# Access Compliance Report

## Public Rights-of-Way

Intersection ID: 27951	Main Street: EDINDALE_DR	Cross Street: SCOURIE_LN	Location: SE
ADA ID: 75C4D7110AE8	Ramp Type: PerpDiag	Initial Pass/Fail: Fail	Overall Compliance: No
Severity Score: 12.5			
Codes/Mitigation Info/Possible Solution		Field Measurements/Component Compliance

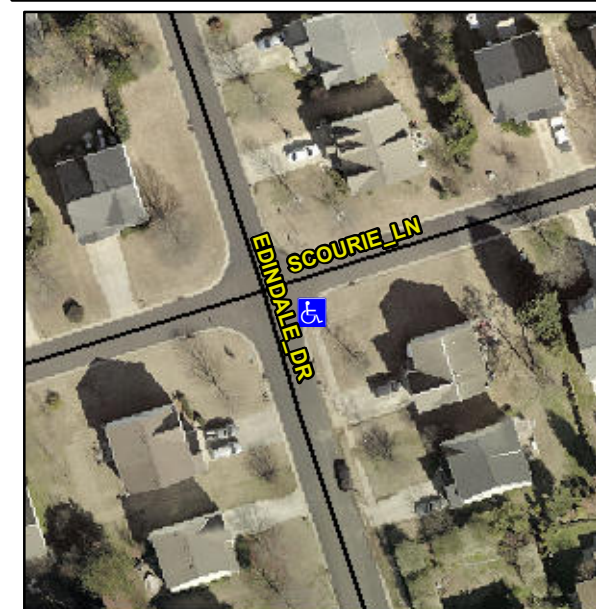
**Remove & Replace Curb Ramp With Two New Directional Ramps or Equivalent.**

**Not Found, R304.5.3**
